REMARKS

IN THE DRAWINGS:

Applicants submit Replacement and Annotated Sheets for Figures 4 and 7. Applicants respectfully request that new Figures 4 and 7, submitted herewith be substituted for the originally filed Figures 4 and 7.

FIG. 4

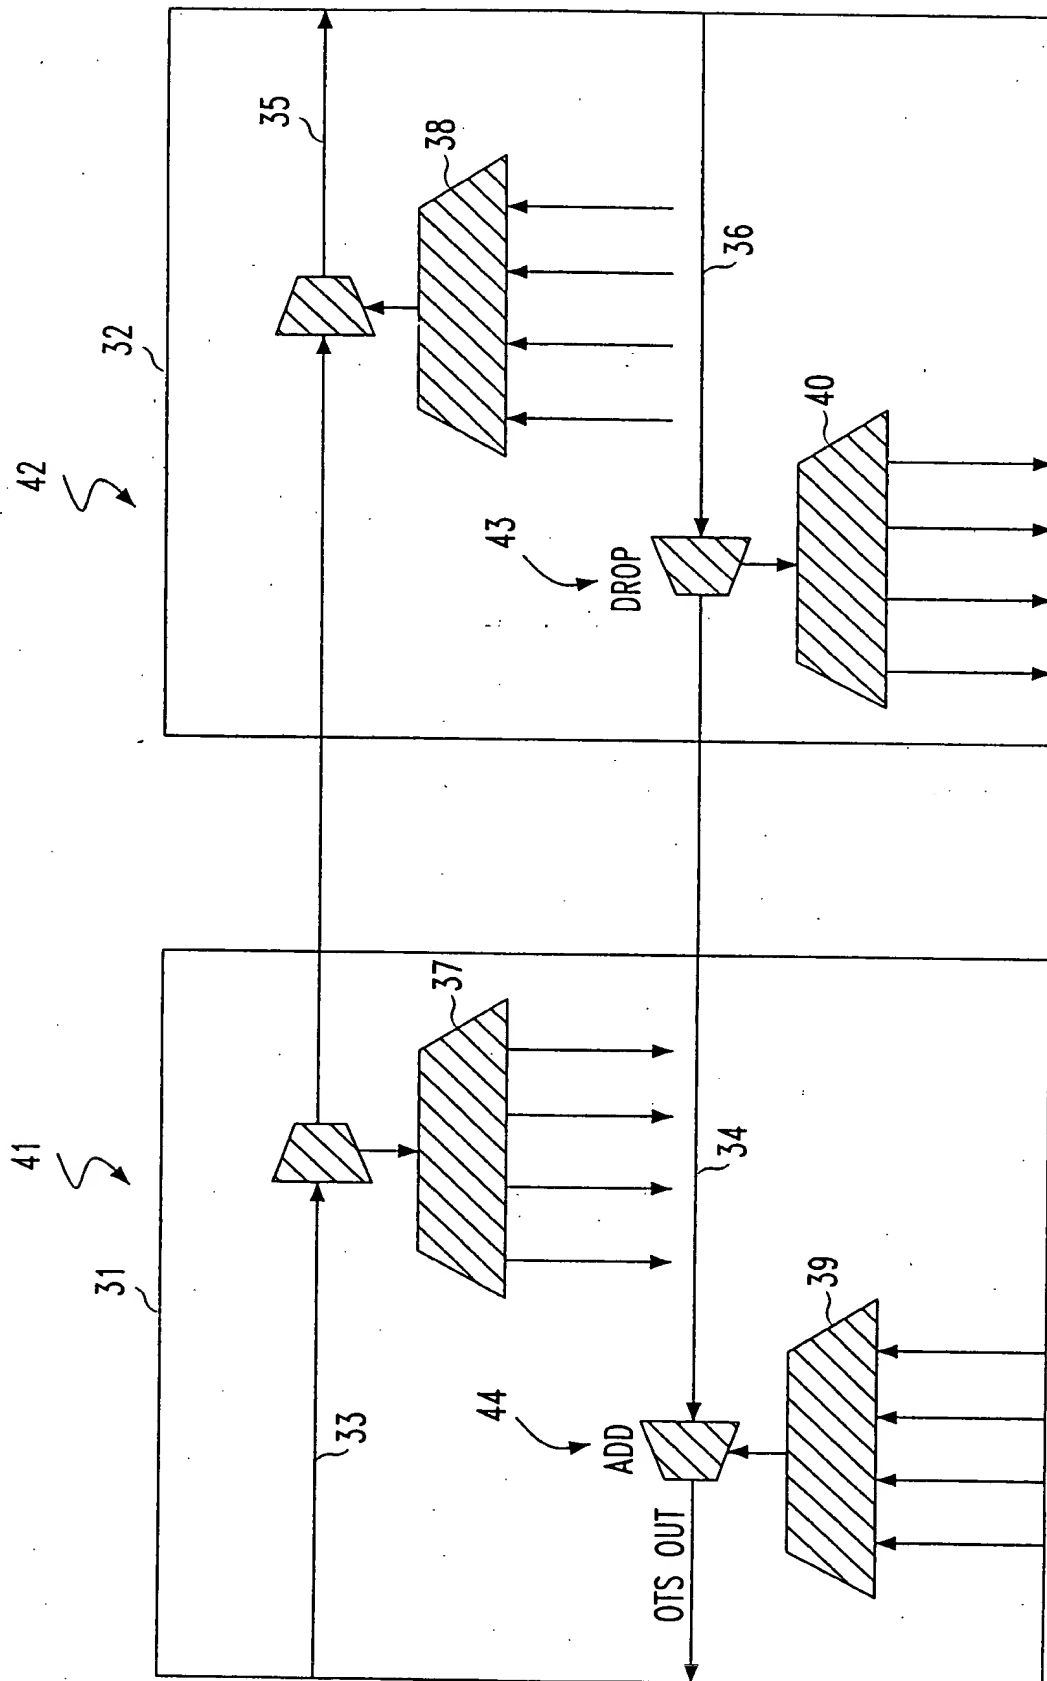
With respect to the drawings, Applicants are taking this opportunity to correct informalities in Figures 4 and 7. In the lower left of Figure 4, “34” is being changed to “30,” which generally identifies the duplex link shown in Figure 4. In Figure 7, “111” is being changed to “110” to identify the bandpass filter.
